November 1, 2023

**WHITE PLAINS CITY SCHOOL DISTRICT
AC AND VENTILATION UPGRADES AT
MAMARONECK AVENUE ELEMENTARY SCHOOL
SED Control Number: 66-22-00-01-0-010-017**

**CONTRACT H- HVAC WORK
CONTRACT E - ELECTRICAL WORK**

DRAWING No.
M110.00

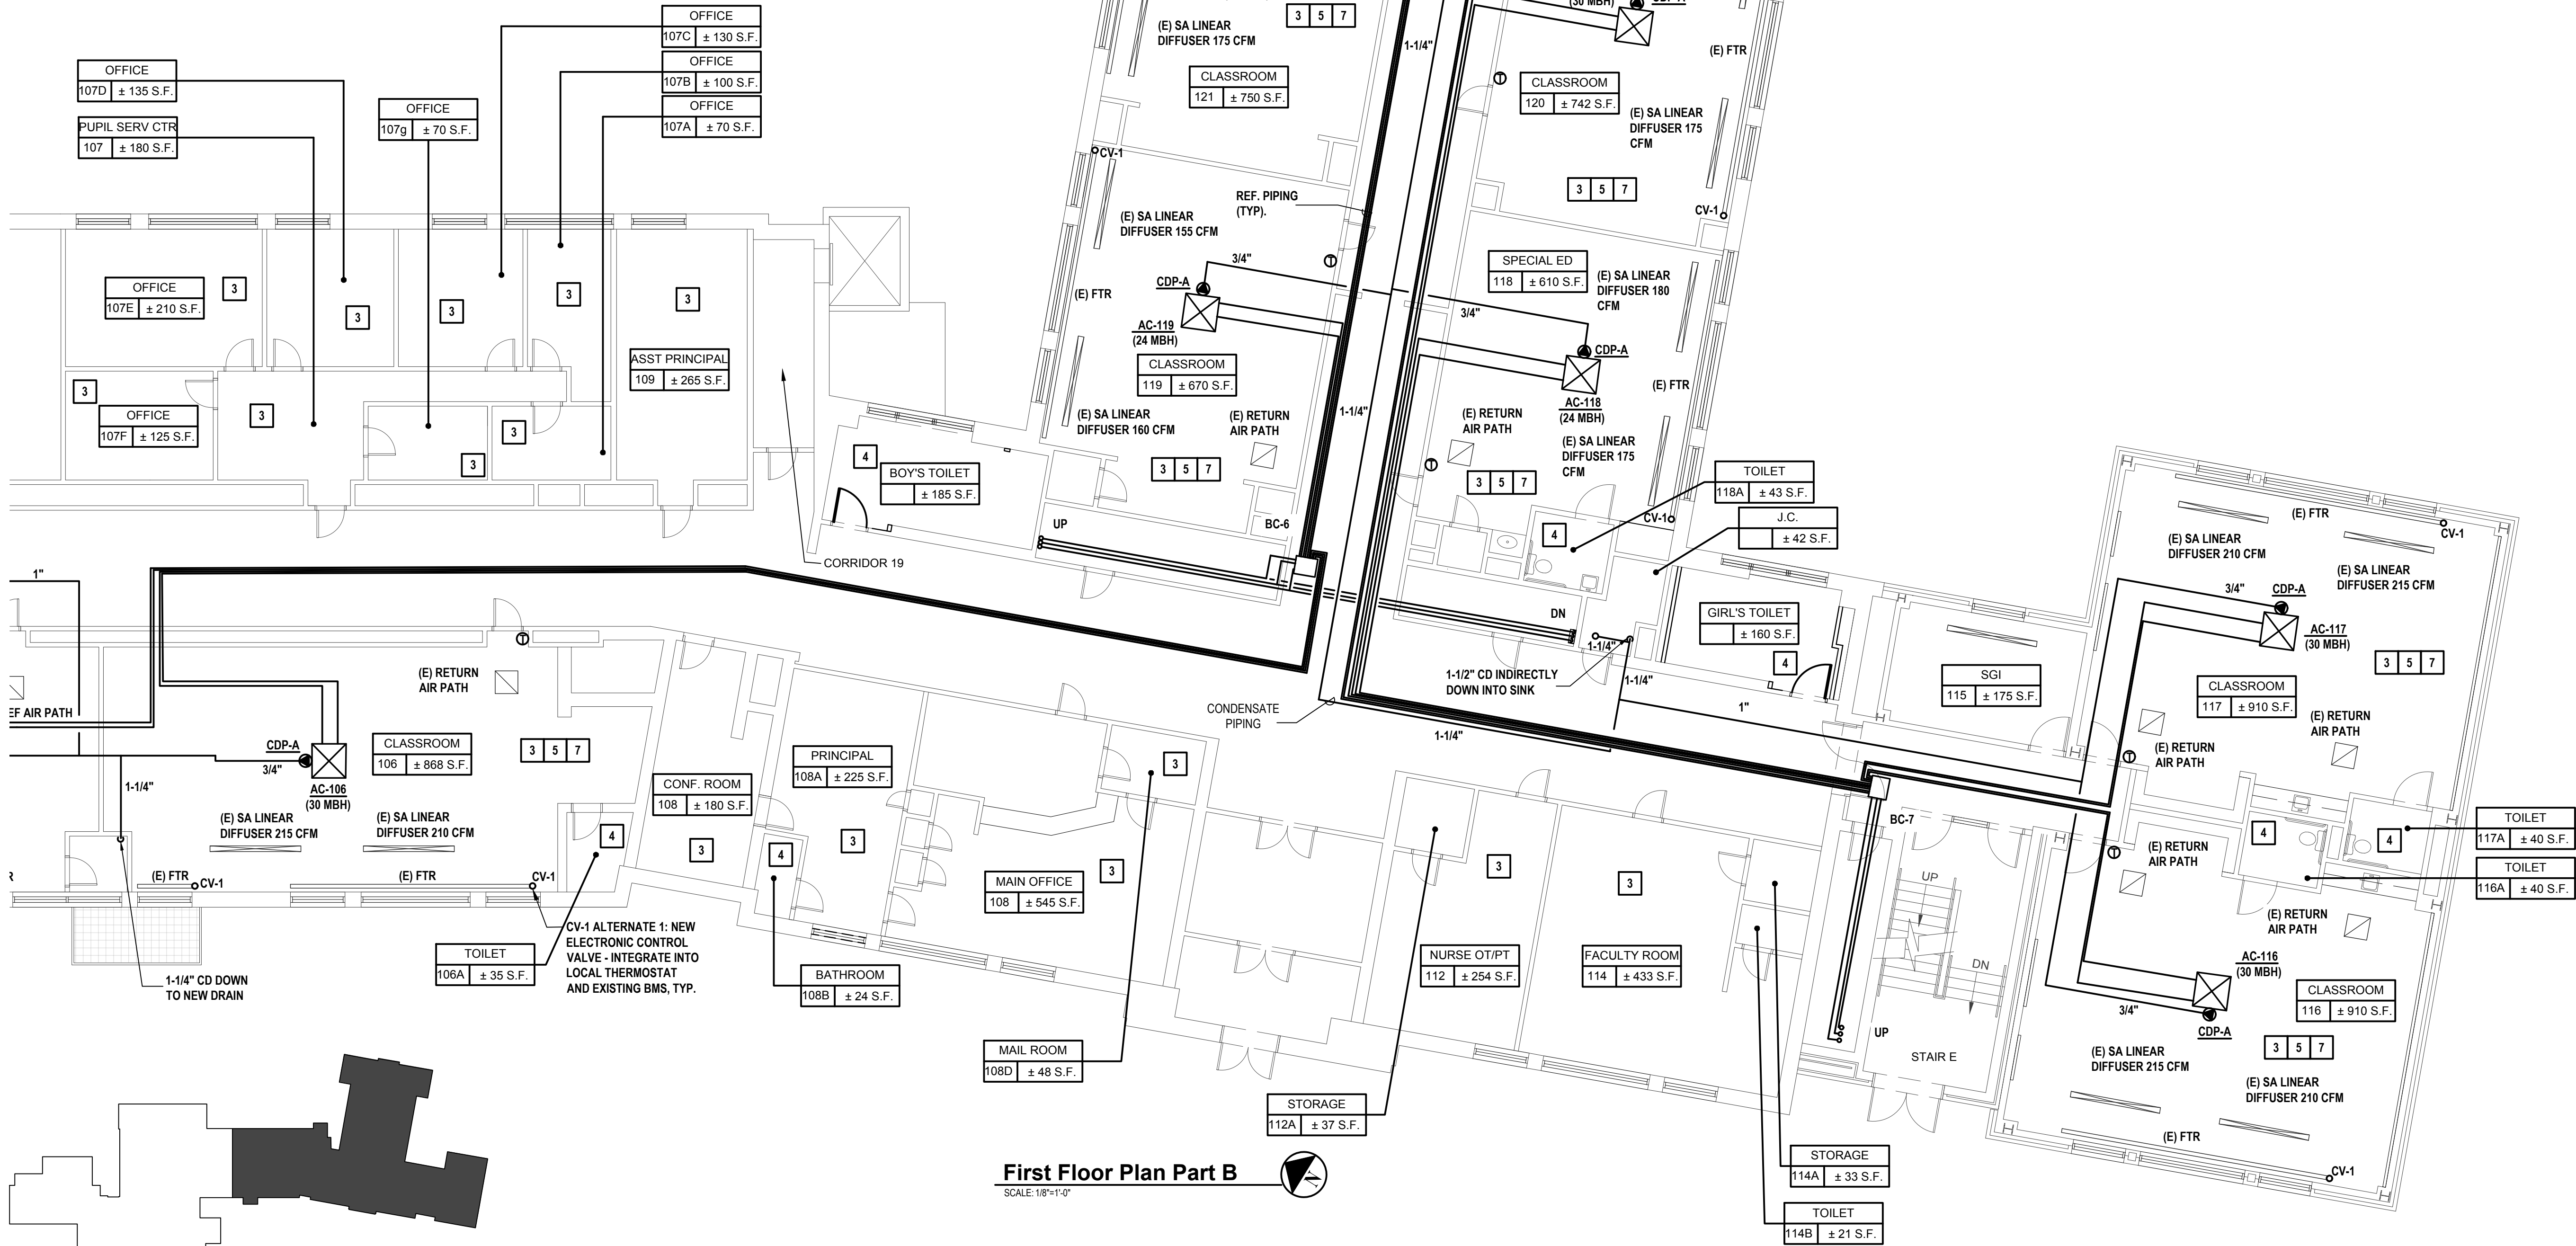
14. REMOVE DRAWING M110.00 MECHANICAL FIRST FLOOR PLAN PART A AND REPLACE WITH REVISED DRAWING M110.00 MECHANICAL FIRST FLOOR PLAN PART A. attached herewith. Please note that this drawing has been revised to clarify scope for the chase work, and mechanical work.
